**DATE** April 13, 2018**PROJECT No.** 1535751**TO** Sasha McLeod  
Ministry of Environment and Climate Change**CC** Nancy O'Neill**FROM** Callum Squires, Golder Associates**EMAIL** callum\_squires@golder.com**WATAYNIKANEYAP PHASE 1 FINAL ENVIRONMENTAL ASSESSMENT – REVISED TRANSFORMER STATION LOCATION AND ASSOCIATED TRANSMISSION LINE RE-ALIGNMENT**

PROJECT  
**PHASE 1 NEW TRANSMISSION LINE TO PICKLE LAKE PROJECT**

PROJECT NO. 1771849      CONTROL -      REV. A      FIGURE 1

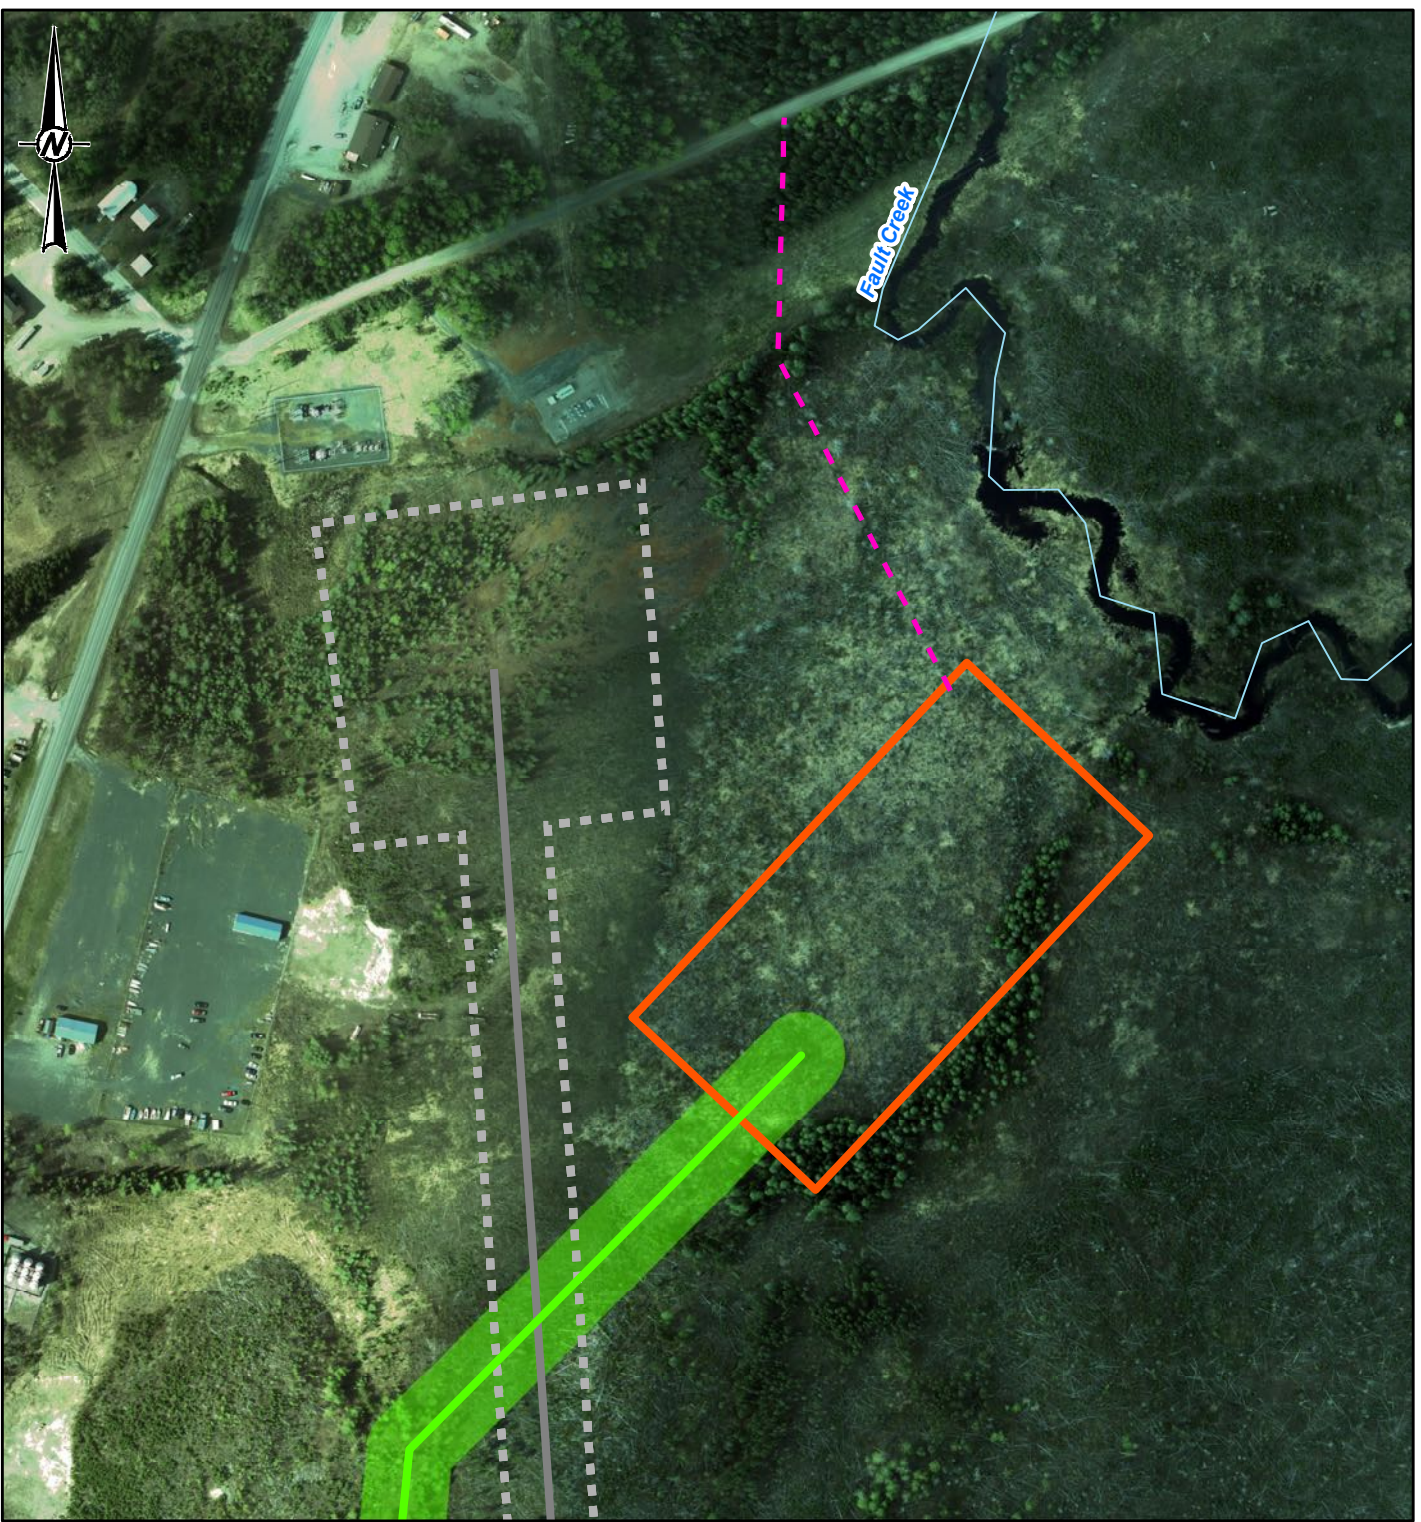
In the Final EA Report, Wataynikaneyap noted that Phase I and II environmental site assessments were completed in the summer of 2017 at the proposed Transformer Station (TS) site located in Central Patricia, north east of Pickle Lake. These studies subsequently identified contamination related to historical mine tailings near the proposed TS site. Wataynikaneyap determined that the contamination levels present at this location were not acceptable for the TS site due to various health, safety, and environmental considerations. As such, Wataynikaneyap completed additional Phase II environmental site assessments in December 2017 at two other potential sites within approximately 300 m of the originally proposed TS site. The footprints of both sites were determined to be free of historical contamination and Wataynikaneyap selected one of these sites as the new proposed TS site (Figure 1).

The movement of the TS site also requires a corresponding realignment of the transmission line as well as changes to the associated access roads. The new proposed TS site will also require an access road connecting the TS site to the road north of the site. The new TS site, transmission line and access roads are collectively referred to herein as the amended Project footprint.

The layout of the new TS is expected to be an area of approximately 226 m by 116 m (2.62 ha) compared to the old location which was expected to be approximately 2.2 ha. With the change in layout, the equipment configuration within the TS site fence line will change slightly; however, no new equipment will be required as a

result of the proposed amendment. To access the new location, a new approximately 0.3 km of access roads will be constructed. The new TS and access road are shown on Figure 1.

PROJECT NO. 1535751 CONTROL - REV. A FIGURE 2

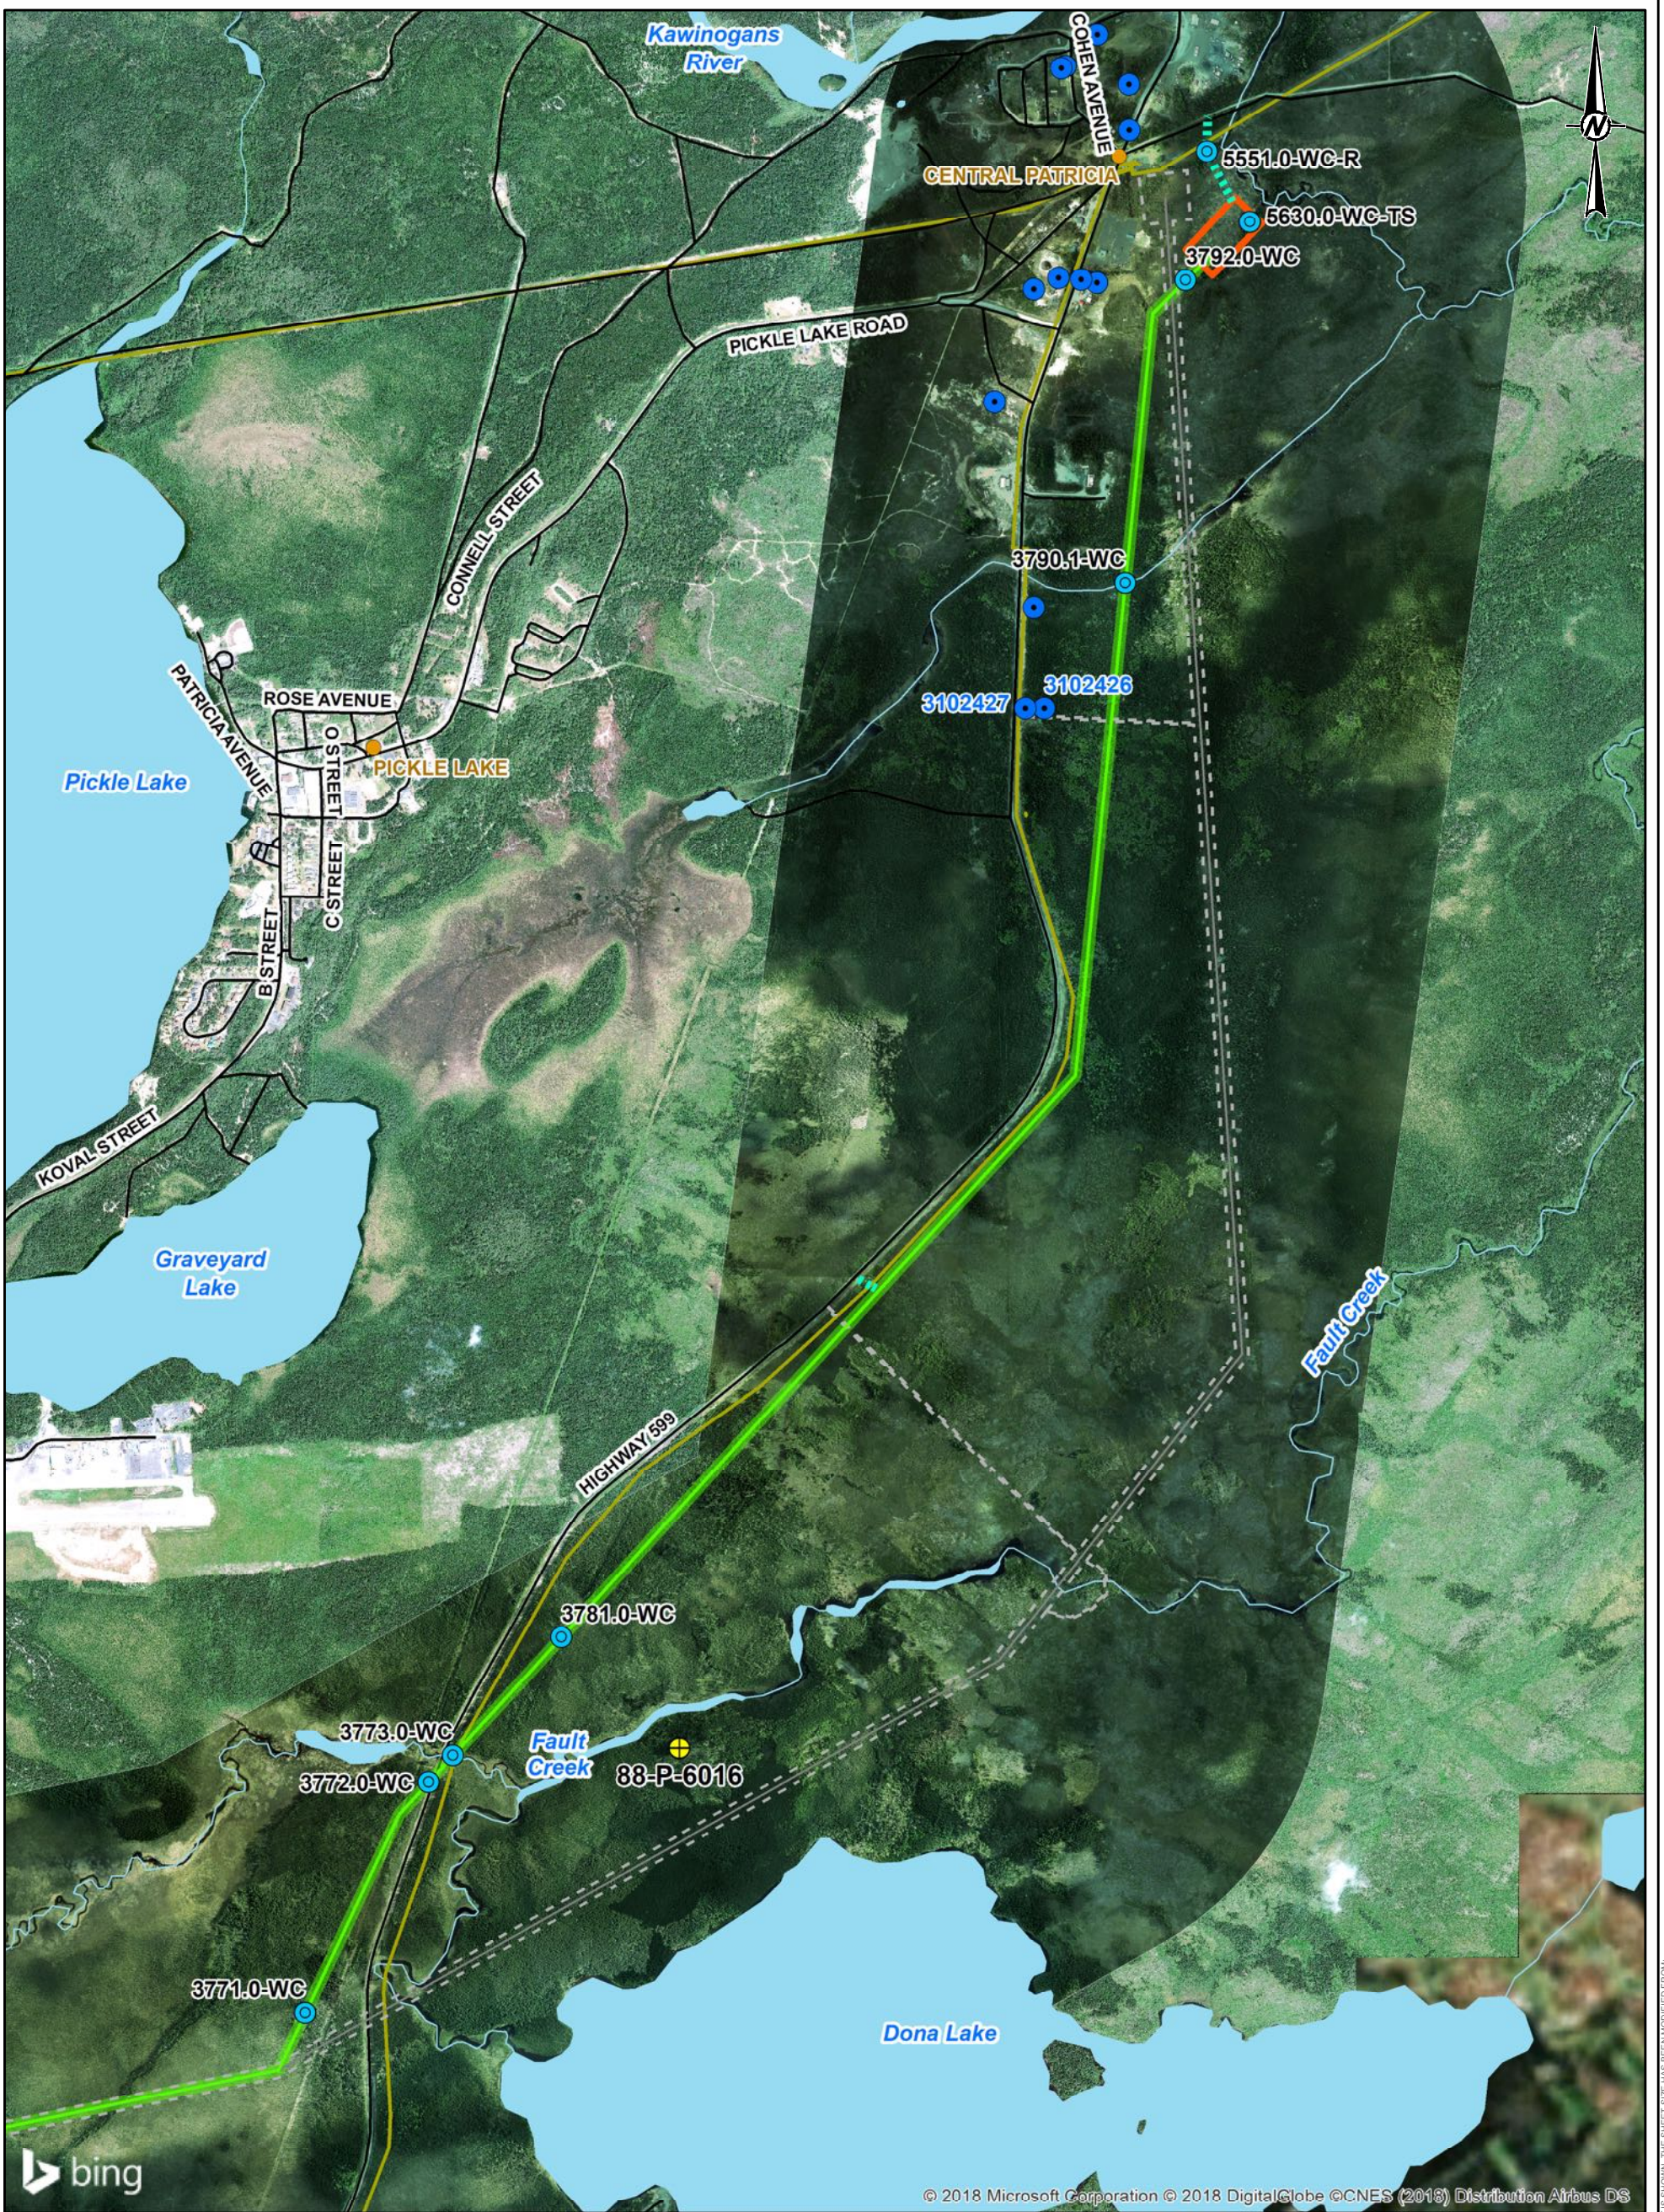
A summary of these changes are described in Table 1 and additional details are provided in the sections below. The new proposed TS site is shown on Figure 1 and the revised transmission line alignment is shown on Figure 2.

Moving the TS site requires an adjustment to the proposed transmission line alignment where it connects to the new TS site. Further, as part of the Final EA Report, Wataynikaneyap committed to minimizing the Project footprint where possible during the detailed design stage. As part of this process, Wataynikaneyap identified an opportunity to adjust the transmission line alignment to more closely follow Highway 599. Therefore, the northernmost portion of the transmission line ROW has been re-aligned between Dona Lake and where it connects to the new TS site. The realignment occurs where all three corridors (Preliminary Proposed Corridor, Corridor Alternative Around Mishkeegogamang, and Corridor Alternative Through Mishkeegogamang) overlap. This re-alignment reduces the total length of the transmission line ROW as well as reduces the amount and length of access roads. The new transmission line ROW and access roads are shown on Figure 2.

There are a total of seven new waterbody crossings: six waterbody crossings on the 40-m-wide transmission line realignment (crossings 3771.0-WC, 3772.0-WC, 3773.0-WC-P, 3781.0-WC, 3790.01-WC, and 3792.0-WC), and one potential waterbody crossing on a new access road (crossing 5551.0-WC-R) (see Figure 2). A review of the footprint of the TS also identified the potential for an unmapped waterbody to be present in the TS boundary (5630.0-WC-TS) (Figure 2).

A site reconnaissance survey will be completed in the spring or summer to determine the presence/absence of potential waterbodies at the new access road crossing (5551.0-WC-R) and within the TS boundary (5630.0-WC-TS) (Figure 2). The results of these surveys will determine if a waterbody or a drainage feature is present and then appropriate impact management measures and permitting requirements will be identified.

TITLE  
**NOISE ASSESSMENT SITE LAYOUT PLAN**

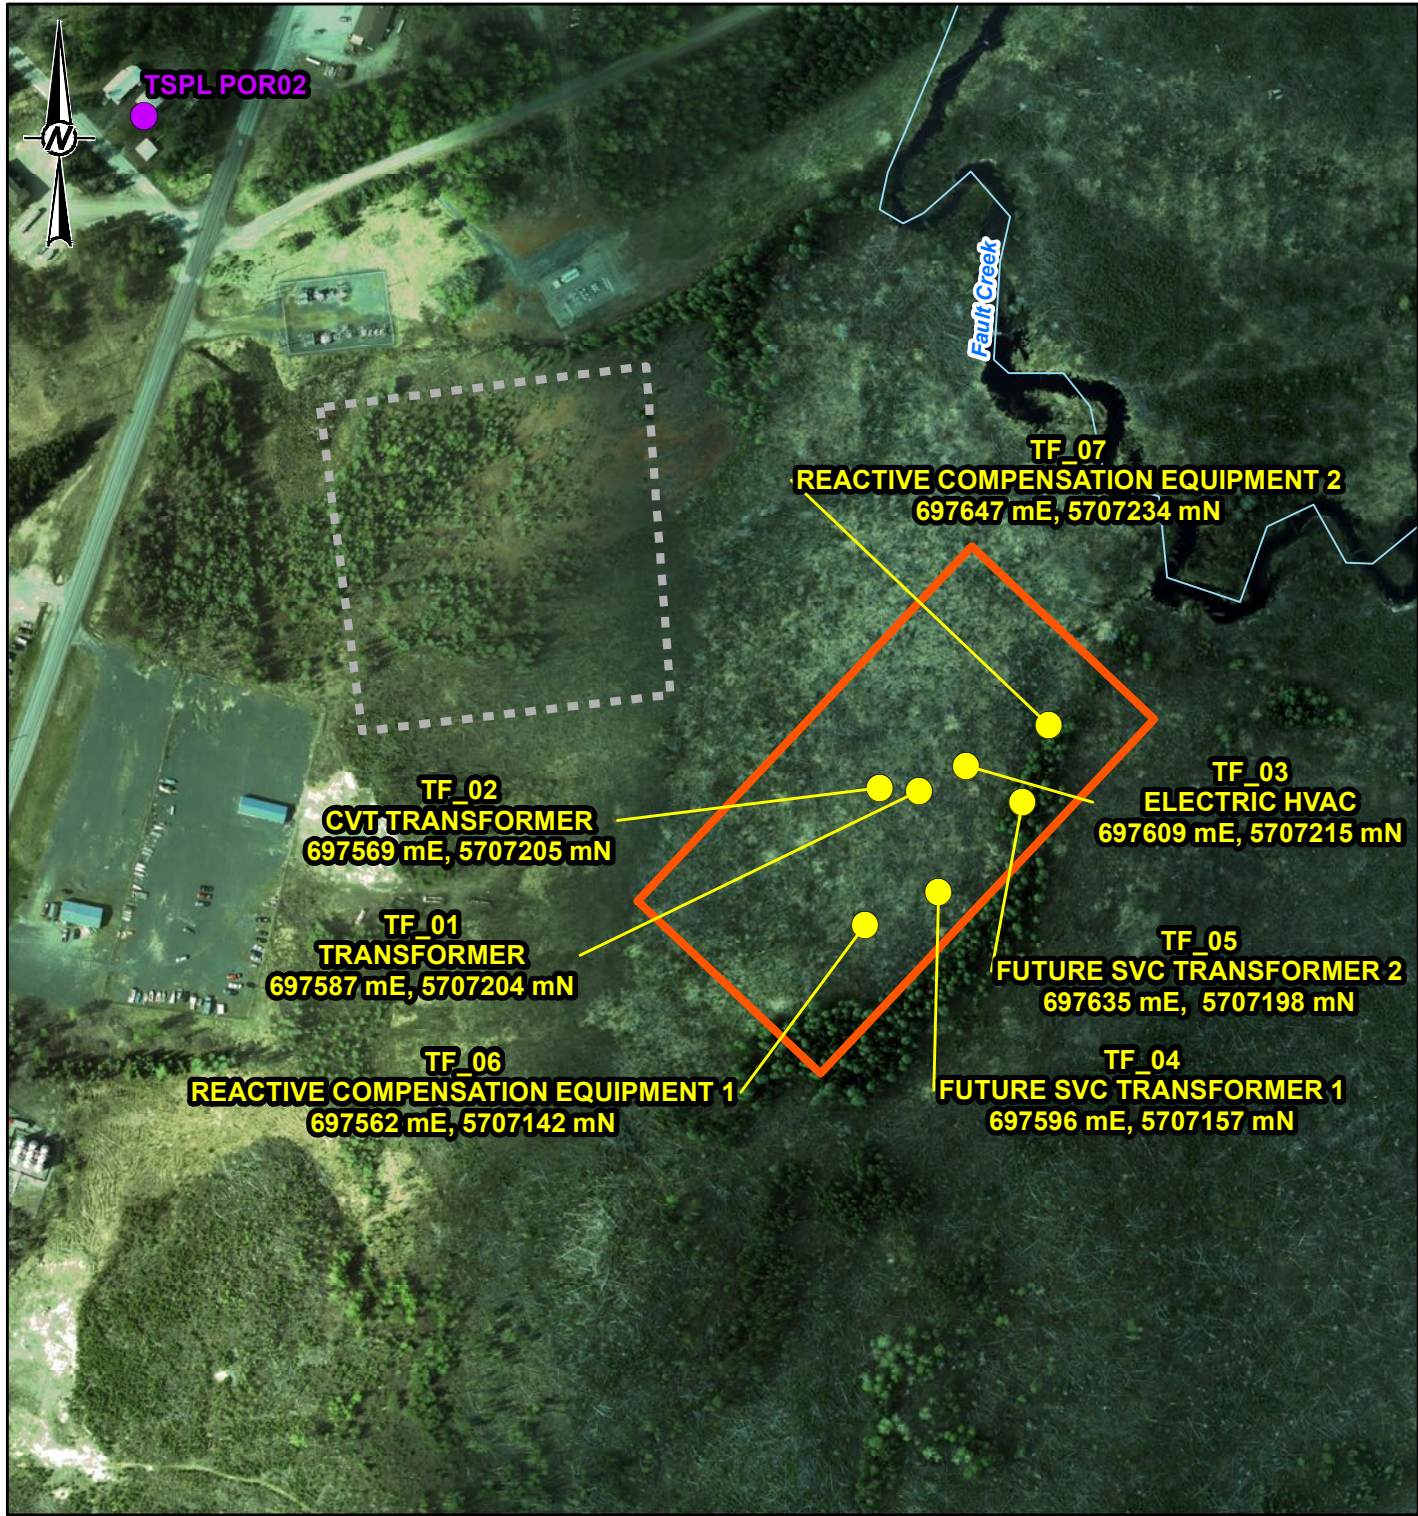
The proposed Pickle Lake TS was quantitatively assessed for the potential effects on the noise environment in the Final EA Report. To consider the potential effects of the new layout on the noise environment, the TS layout considered in the Final EA Report was moved to the new proposed TS footprint (shown on Figure 3). The relative locations of the acoustically substantial noise sources previously assessed in the Final EA Report were maintained.
